PROJECT 1801 FRONTAGE ROAD LIVING GREEN TRAIL PROJECT

ADDENDUM NO. 3

Frontage Road Trail Pre-Bid Q & A- 10-24-2023

- c. Detail 3 on C-8.1:

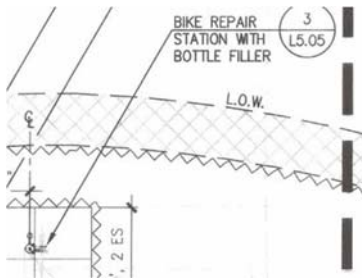
Shows the Catch Basin Structure & Grate per detail 2 & 3 on C7-0. C7-0 is the stormwater Management Plan without details. Please advise.

A: Refer to attached Drain Inlet Base Detail for clarification.

**FRONTAGE ROAD
LIVING GREEN TRAIL DESIGN
HORIZONTAL CONTROL PLAN**

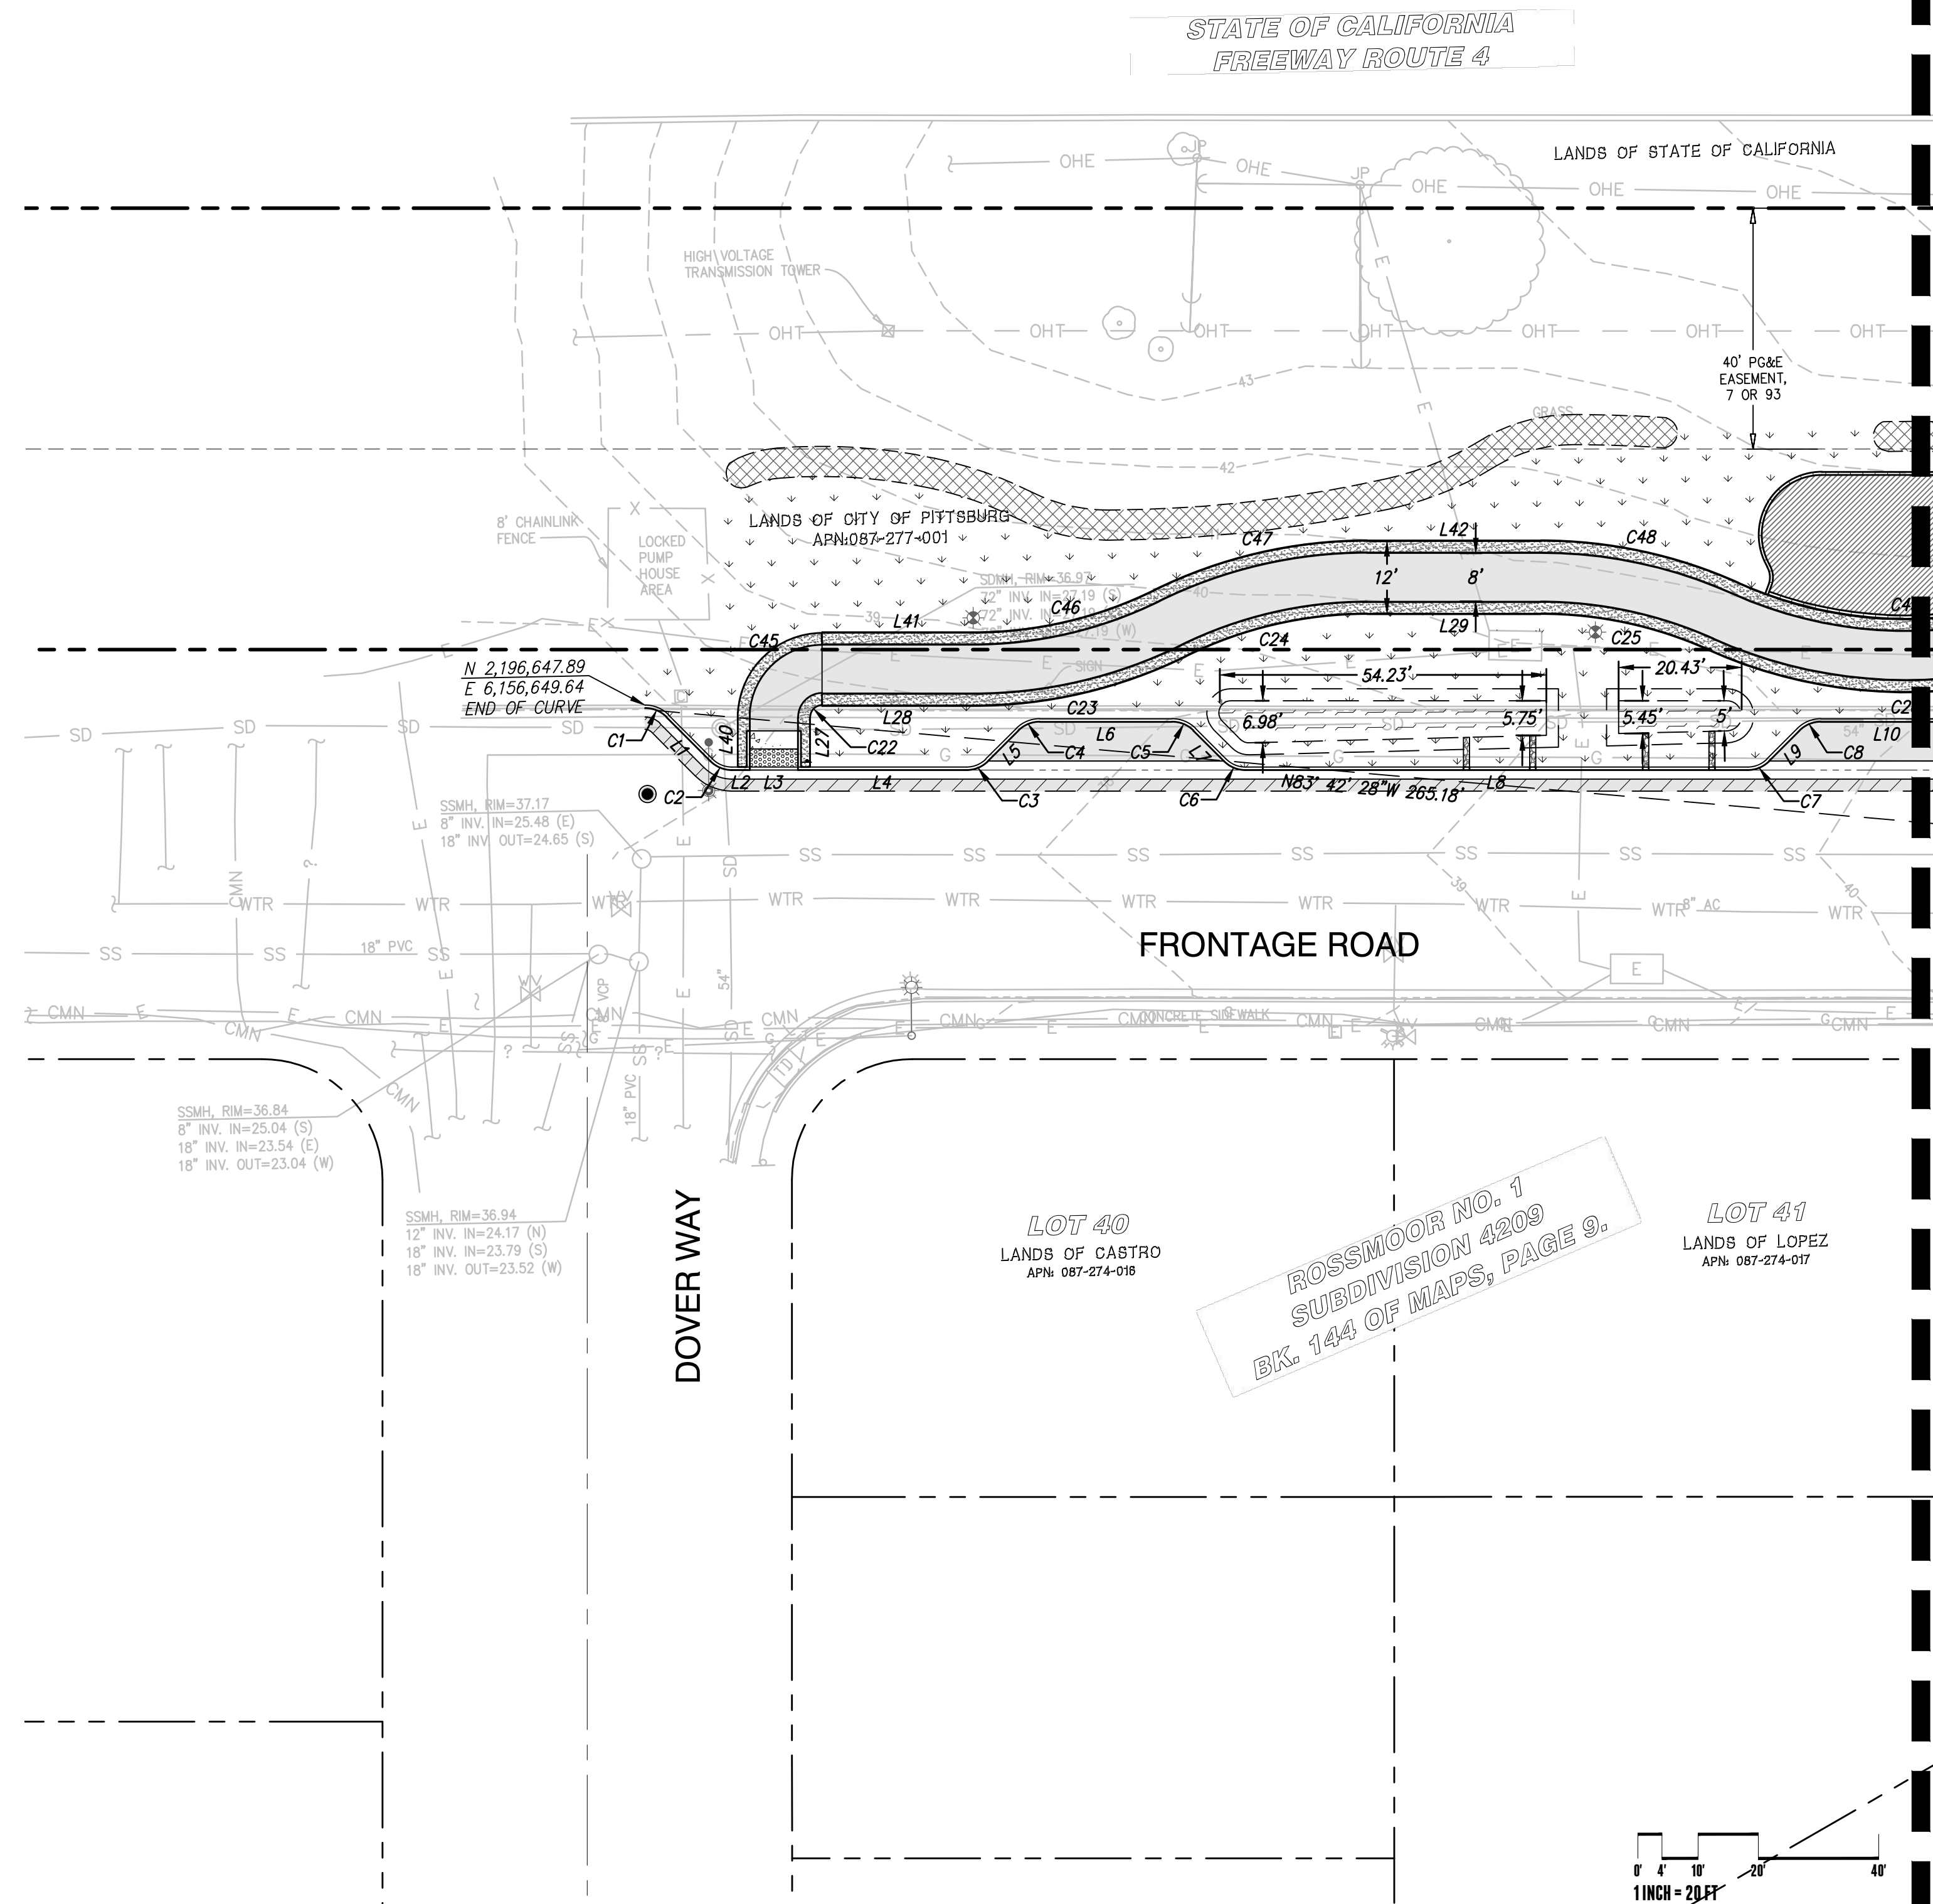
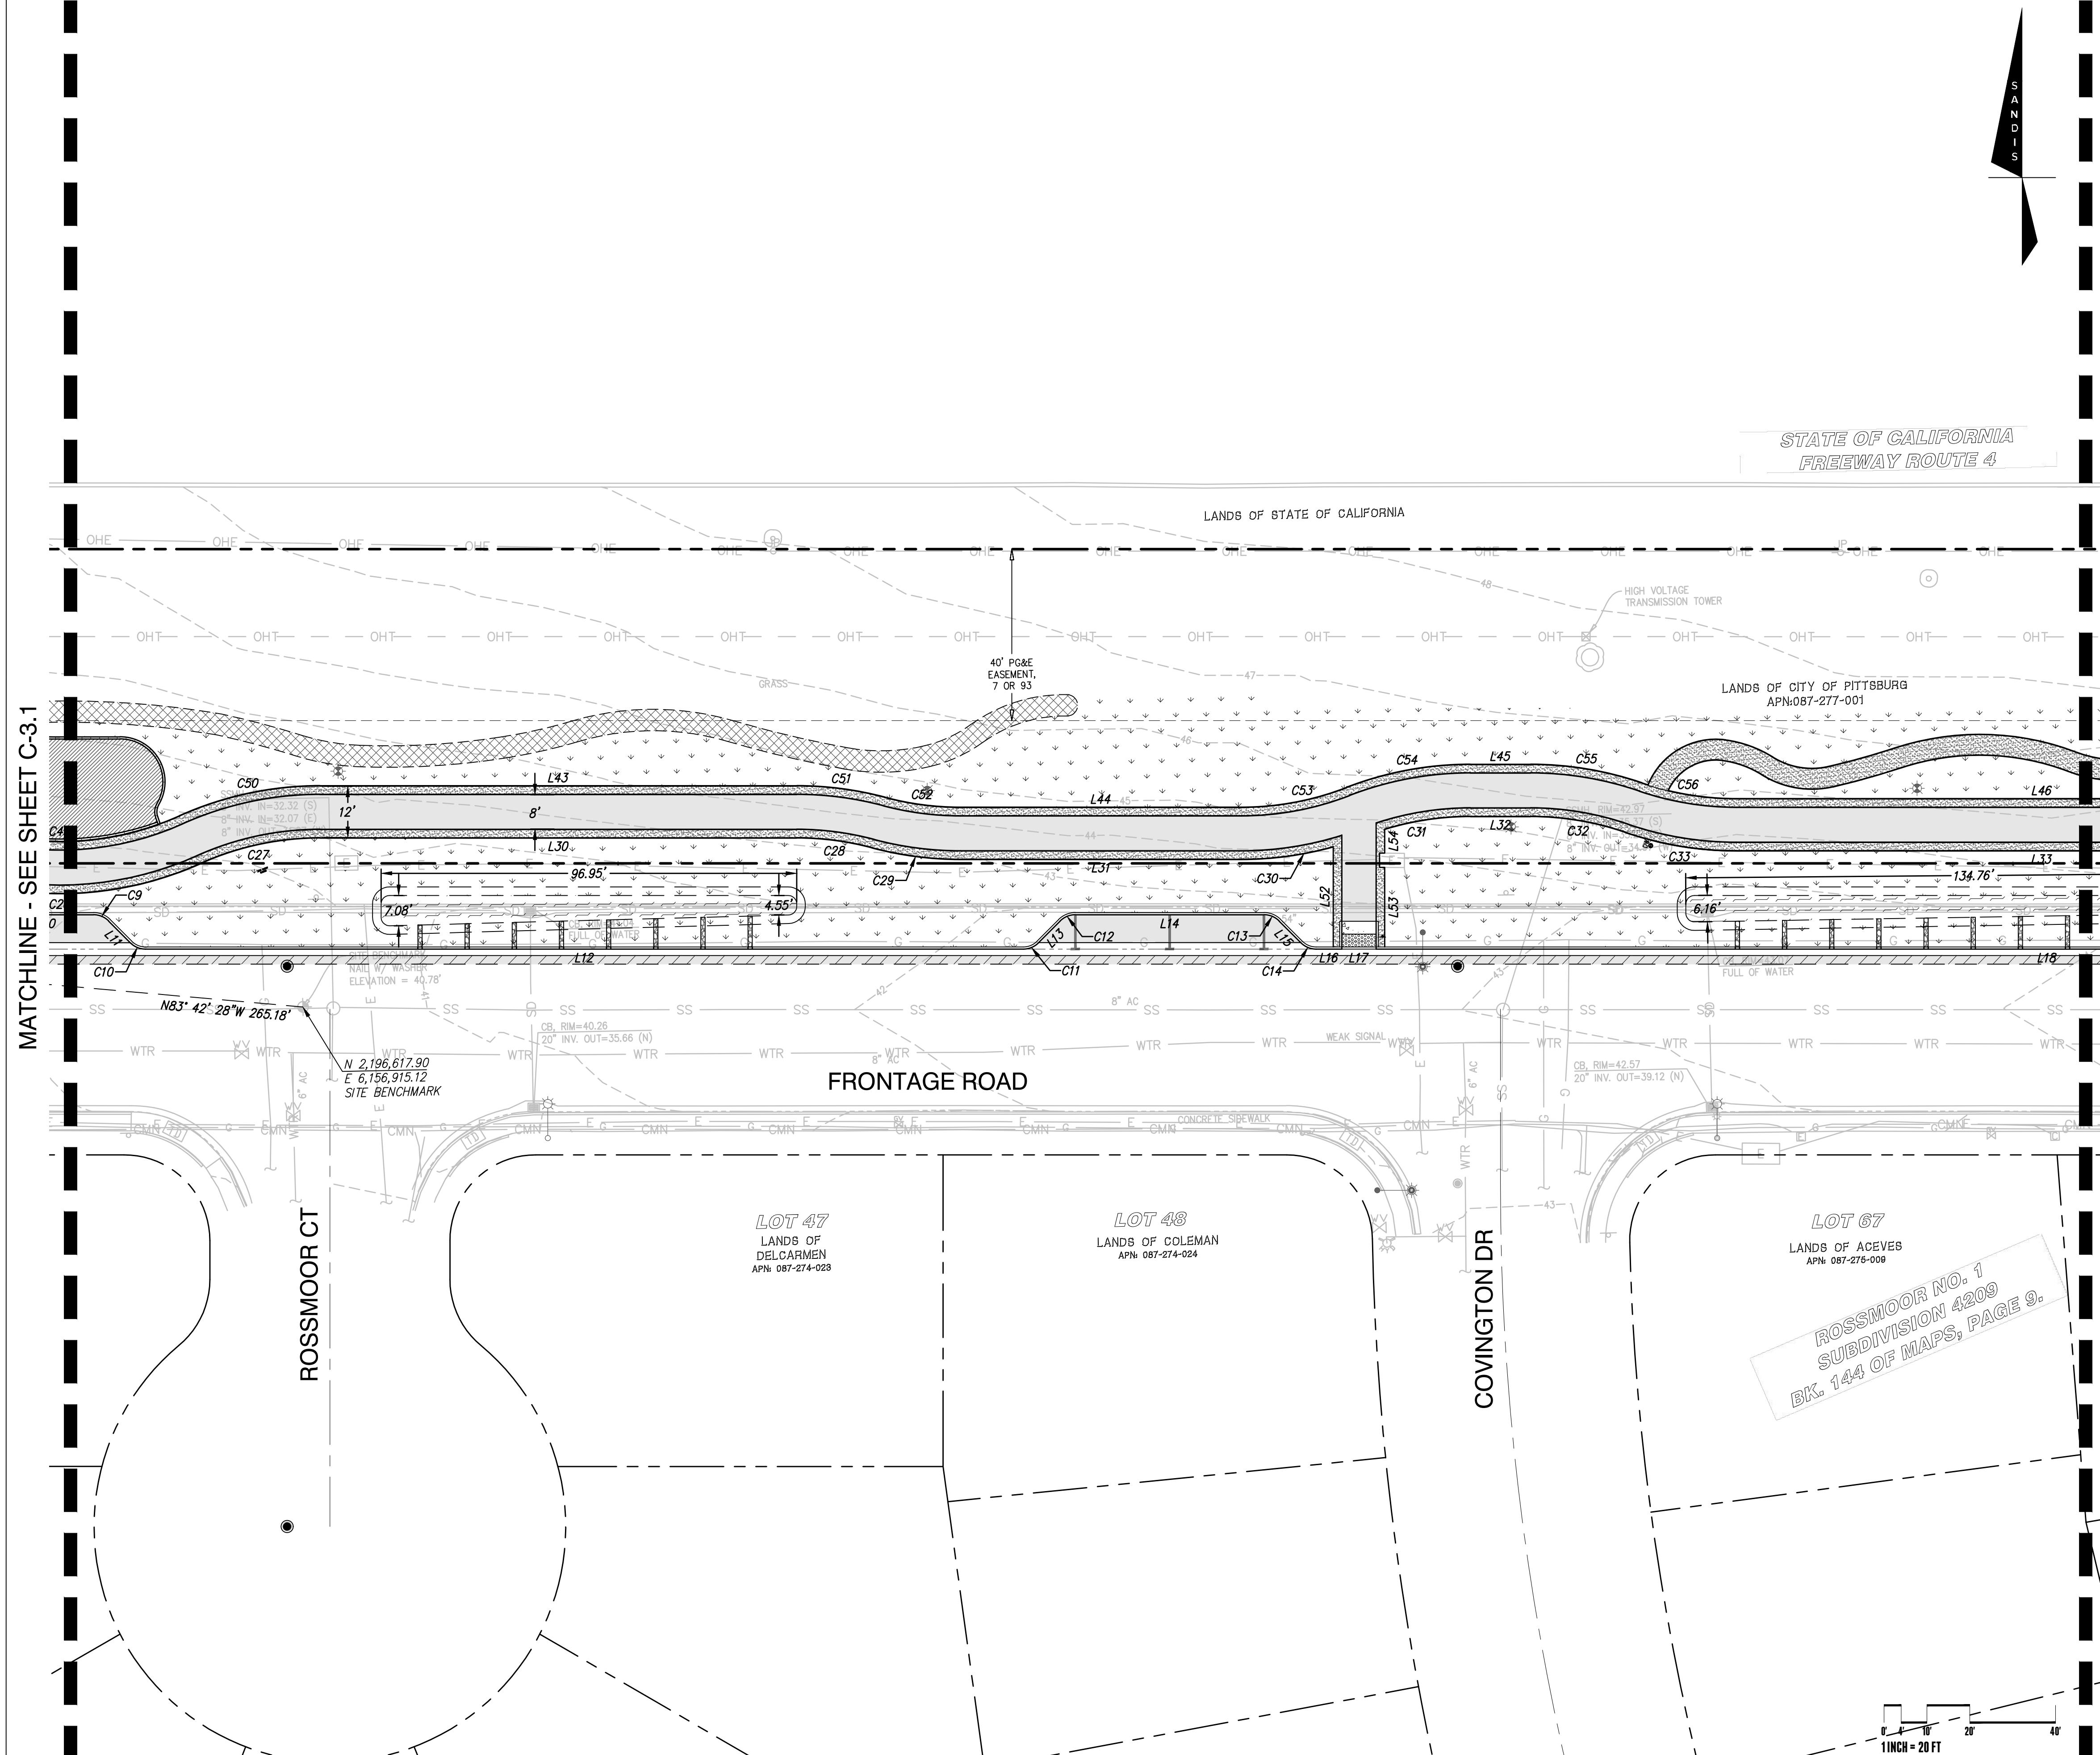
- a. Please be advised of the following clarifications to the contract documents:
 - i. **Concrete Pedestrian Sidewalk Pavement shall be removed and replaced with Asphalt Concrete Pavement with 2 foot decomposed granite shoulders as reflected on the main trail segment. See attached Horizontal Control Plan.**

16. Q: Please clarify horizontal control and layout (line/curve tables, station and offsets) for the project.

A: Refer to the attached horizontal control plan sheets C-3.1 – C-3.4.
